Product Change Notice (PCN)

PCN Number: **PCN-0456171R-01**

Product(s) Affected: **PJ-031DH**

PREVIOUS CUI DEVICES DETAIL / IMAGE	NEW CUI DEVICES DETAIL / IMAGE

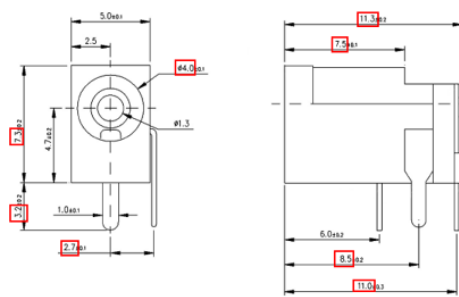
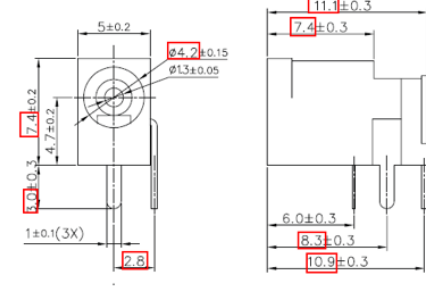
Description of Change: **Product re-engineered for improved manufacturability and production yield. See image below for product changes. Cosmetic differences may be visible and not affect the form fit and function of the product.**

PREVIOUS CUI DEVICES DETAIL / IMAGE			NEW CUI DEVICES DETAIL / IMAGE		
DESCRIPTION	MATERIAL	PLATING/COLOR	DESCRIPTION	MATERIAL	PLATING/COLOR
center pin	brass	silver	center pin	brass	CuSn
terminal 1	brass t=0.50	silver	terminal 1	brass t=0.40	silver
terminal 2	MM alloy t=0.20	silver	terminal 2	stainless steel t=0.20	silver
terminal 3	brass t=0.50	silver	terminal 3	brass t=0.40	silver
housing	PA10T (UL94V-0)	black	housing	PA10T (UL94V-0)	black

<p>MATING PLUG Jack Insertion Depth: 7.0 mm</p>	 <p>MATING PLUG Jack Insertion Depth: 6.2 mm</p>
---	--
